**Draft Environmental and Safety  
Analysis of a Proposed Low-Level  
Radioactive Waste Disposal Facility in  
Andrews County, Texas**

**August 2008**

**Radioactive Materials Division**

**TEXAS COMMISSION ON ENVIRONMENTAL QUALITY**

**Figure EA-5: Changing locations of water table in reservoir-dam system in response to sudden rise in reservoir depth**  
(From: *Soil Mechanics for Unsaturated Soils*, by Fredlund and Rahardjo, 1993, John Wiley and Sons).

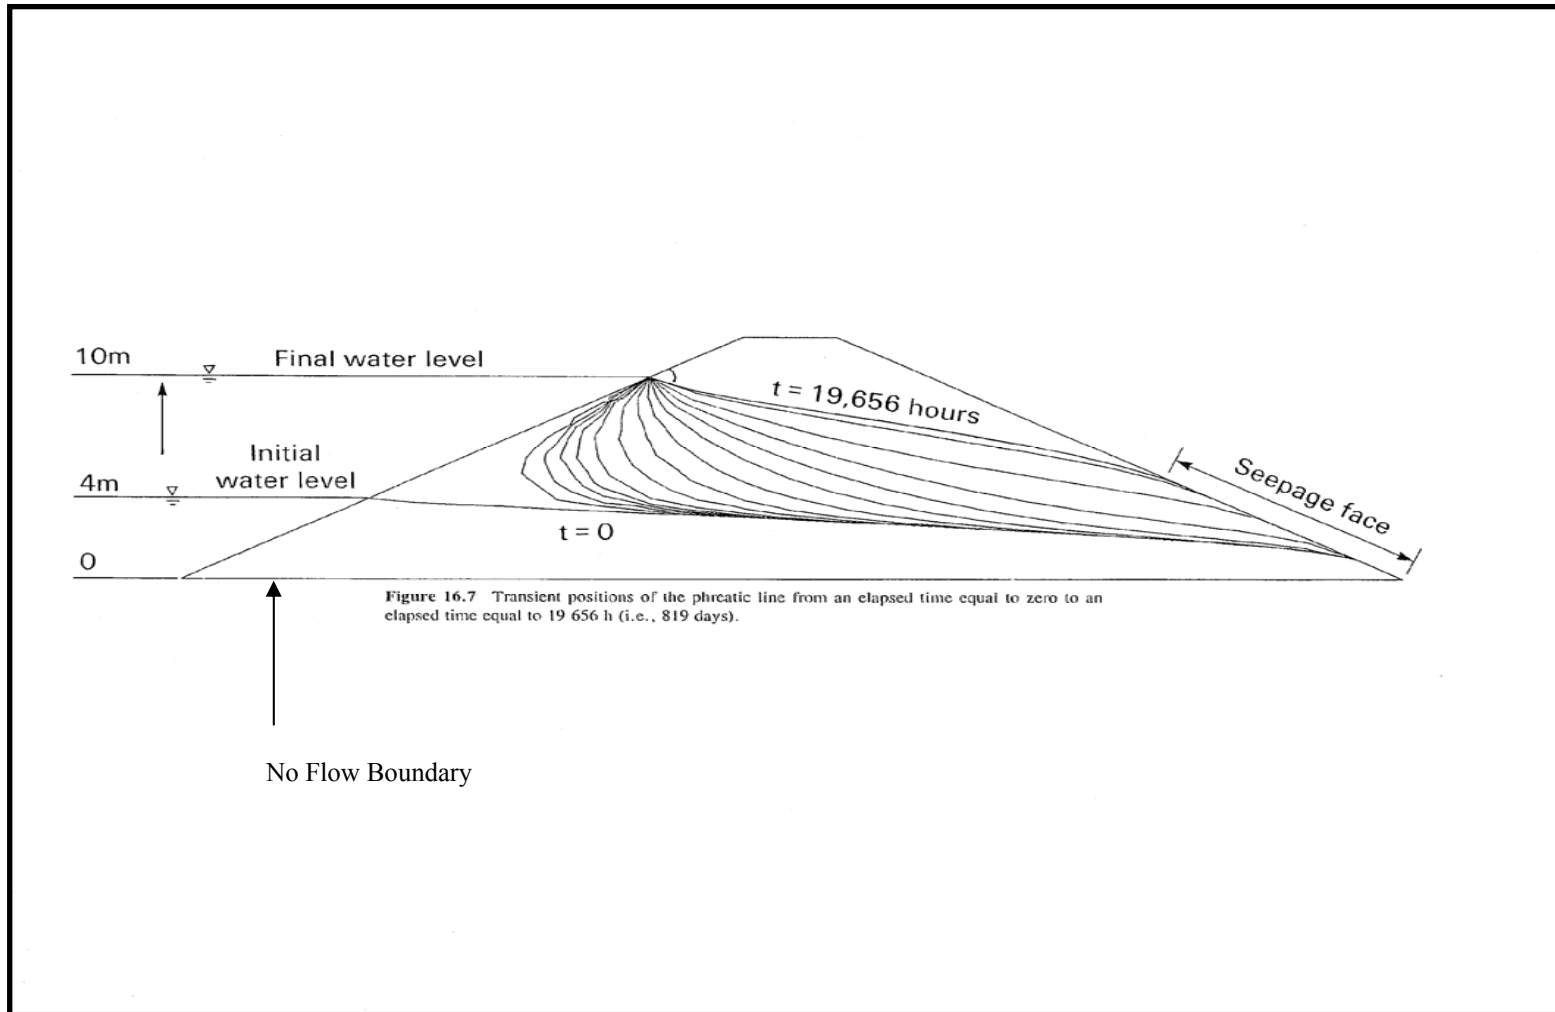
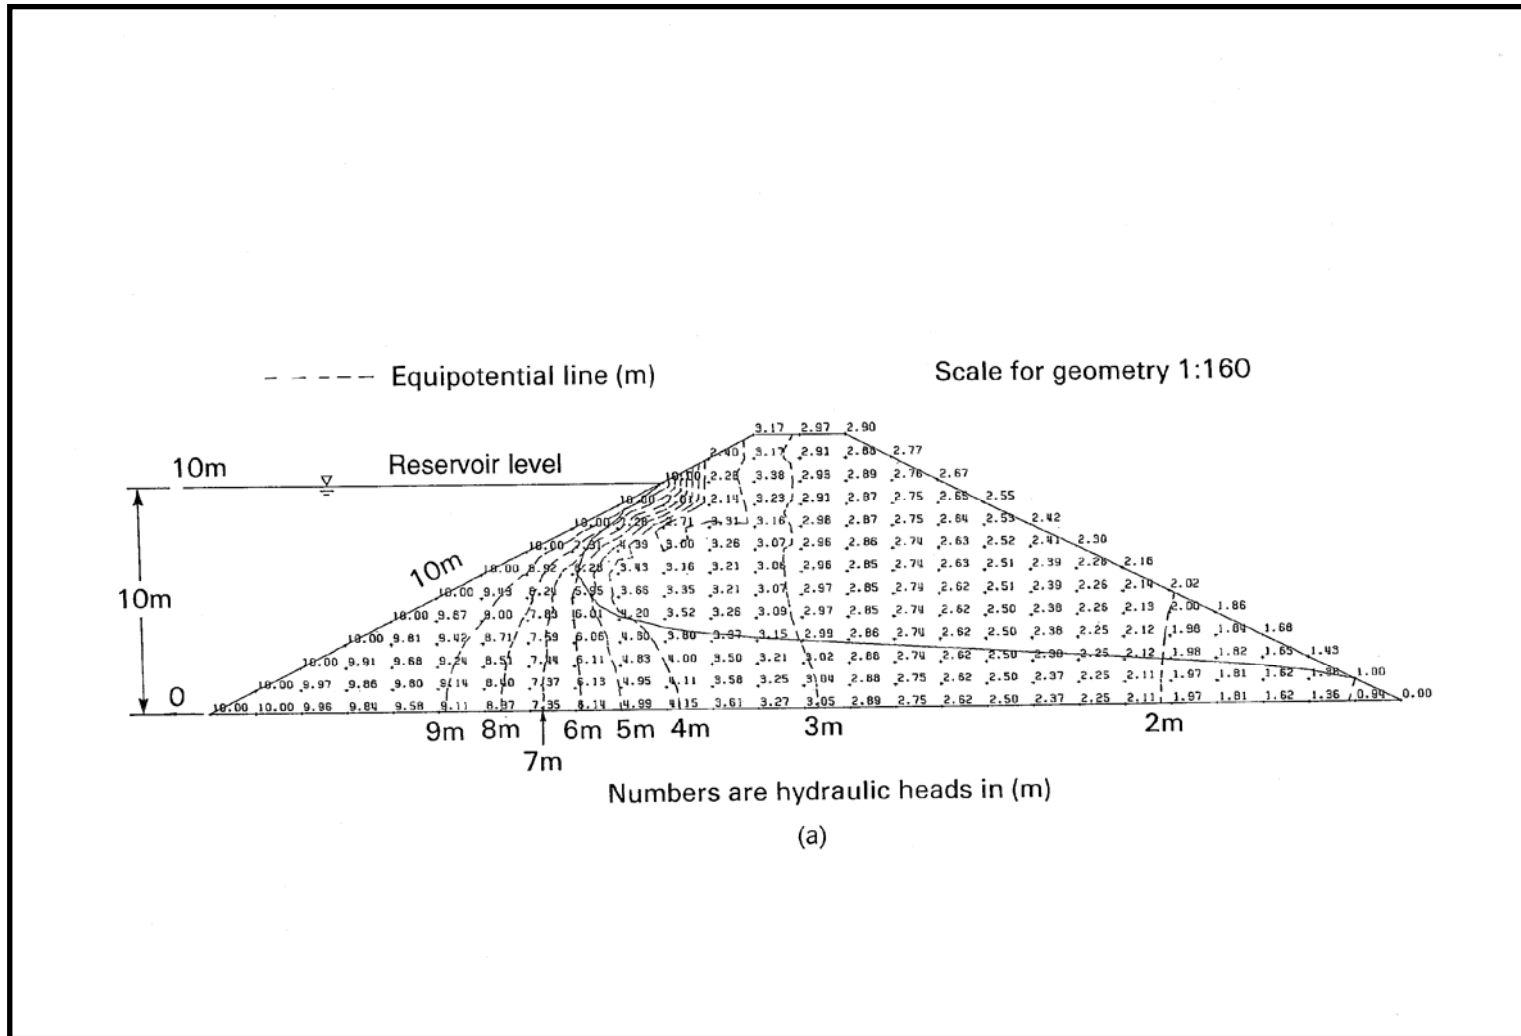
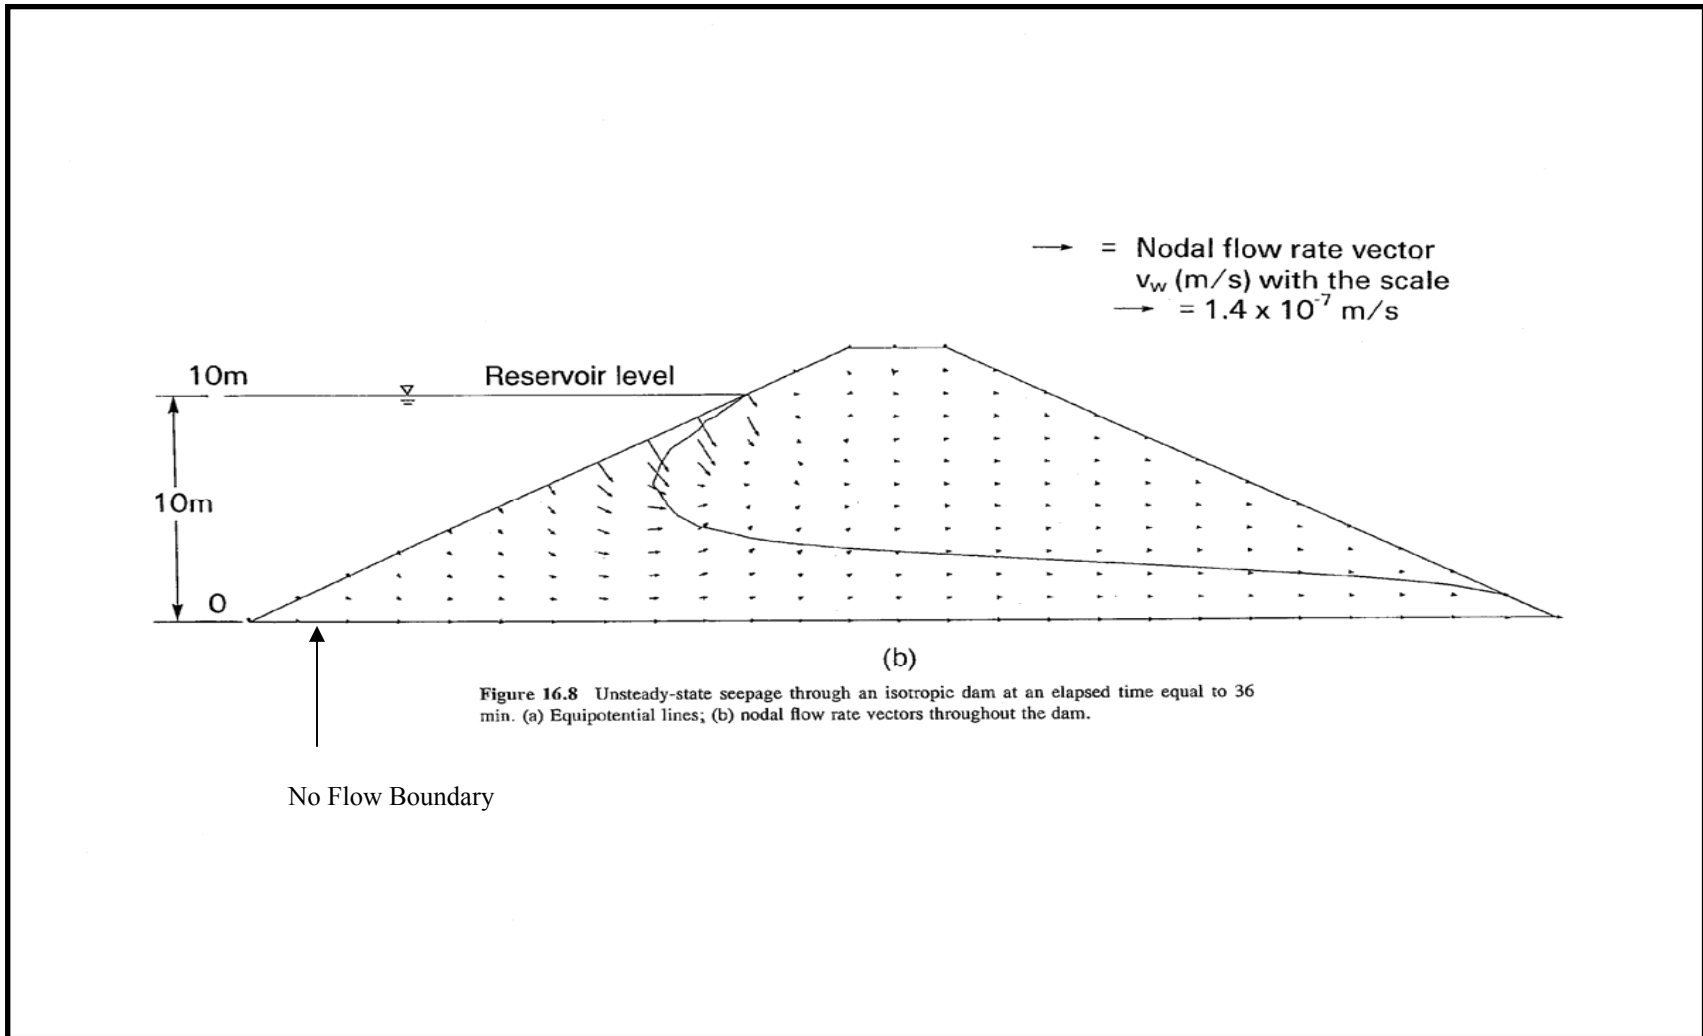
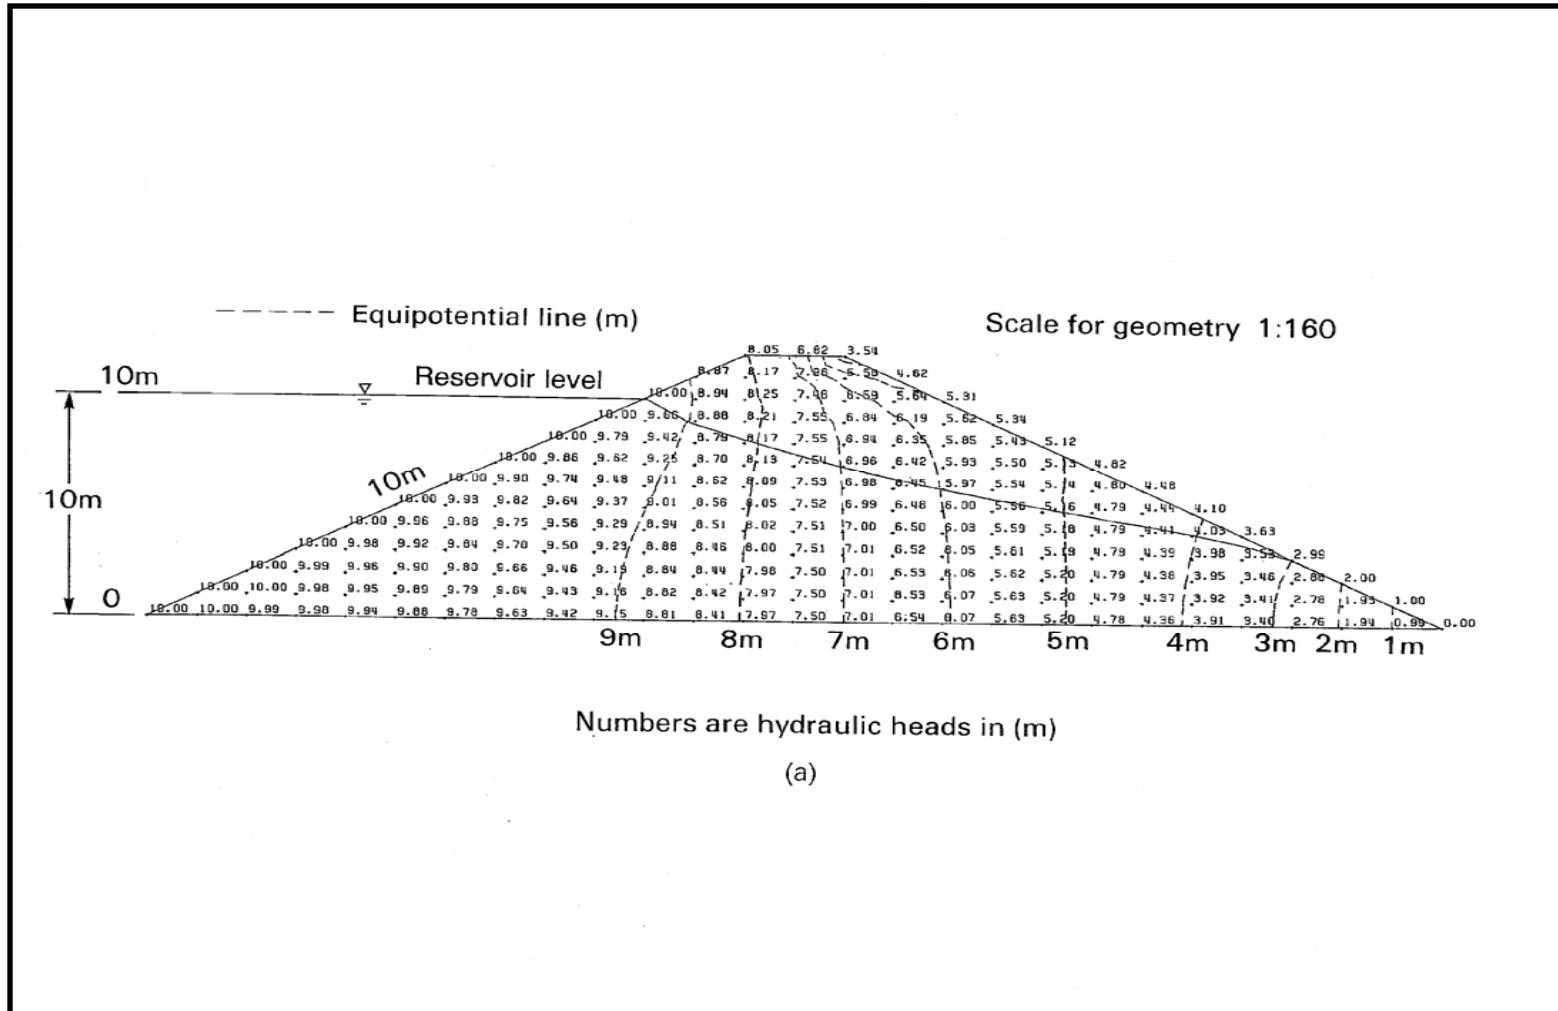
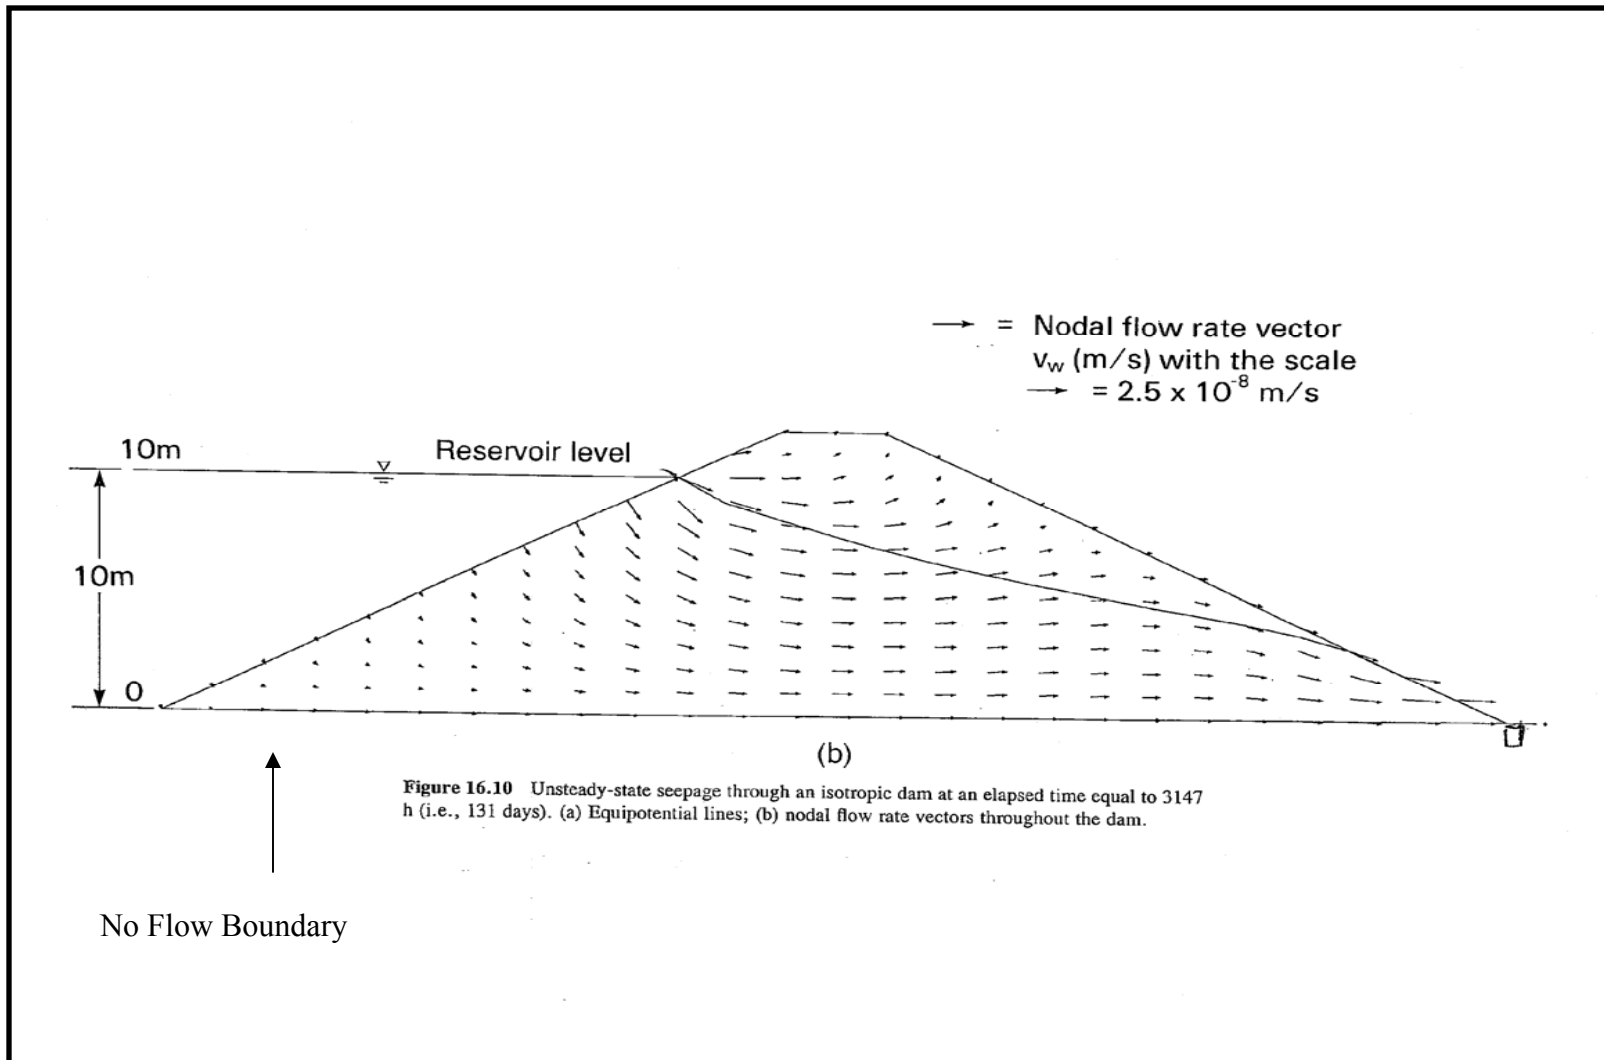
Figure EA-5 shows that the water table in the dam takes 19,656 hours (2.24 years) to return to an equilibrium configuration in response to the sudden increase in reservoir depth. Due to differences in scale and material properties, this does not imply that the water table in the Dockum red bed shown in Figures 6-5a and 6-5b of the application, in response to a sudden lateral expansion of the saturated conditions in the OAG materials would require that same period of time to equilibrate to a future equilibrium configuration. However, Figure EA-5

suggests, that if the current position of the OAG dry line is a sudden perturbation from a steady-state position (as suggested in the application) then the current locus of the water table (corresponding to the  $t=0$  locus in Figure EA-5) might be expected, at some future time to relocate (corresponding to the  $t = 19,656$  hour locus in Figure EA-5). If so, then examination of the site hydrogeologic conceptual model in Figure 6-5b suggests that, at some point in the future, the lower water table, after achieving its new equilibrium position, will intersect the boundaries of the FWF disposal unit. It can be concluded that the features of the reservoir-dam system suggest the plausibility of the hydrogeologic conceptual model presented in Figures 6-5a and 6-5b of the application. This system also suggests that, due to future predicted increases in precipitation, that the potential for upward movement in the lower water table in the Dockum requires a careful examination.

There are several interesting features of the system depicted in Figure EA-5. In this figure, the ten meter water level remains constant even as water flows from the reservoir into the dam to feed the expanding water table. Thus, the point of intersection of the new reservoir water level with the dam surface remains fixed during the evolution of that water lower table. In essence, the reservoir is assumed to be infinite; loss of water from the reservoir into the dam interior does not lower the depth of reservoir. Thus, the system analyzed by Fredlund and Rahardjo shown in Figure EA-5 may be subtly different than the system depicted in the hydrogeologic model in Figures 6-5a and 6-5b of the application.

The reservoir-dam problem from Fredlund and Rehardjo is a two-dimensional problem. On any cross-section parallel to that shown in Figure EA-5 from the text, conditions are identical. The hydrologic conditions at the proposed disposal site are three-dimensional. Because of the curvilinear nature of the OAG dry line on all sets of parallel cross-sections through that site, conditions are different, including the component of flow perpendicular to that cross-section. Thus, the reservoir-dam analogy must be considered with some care.
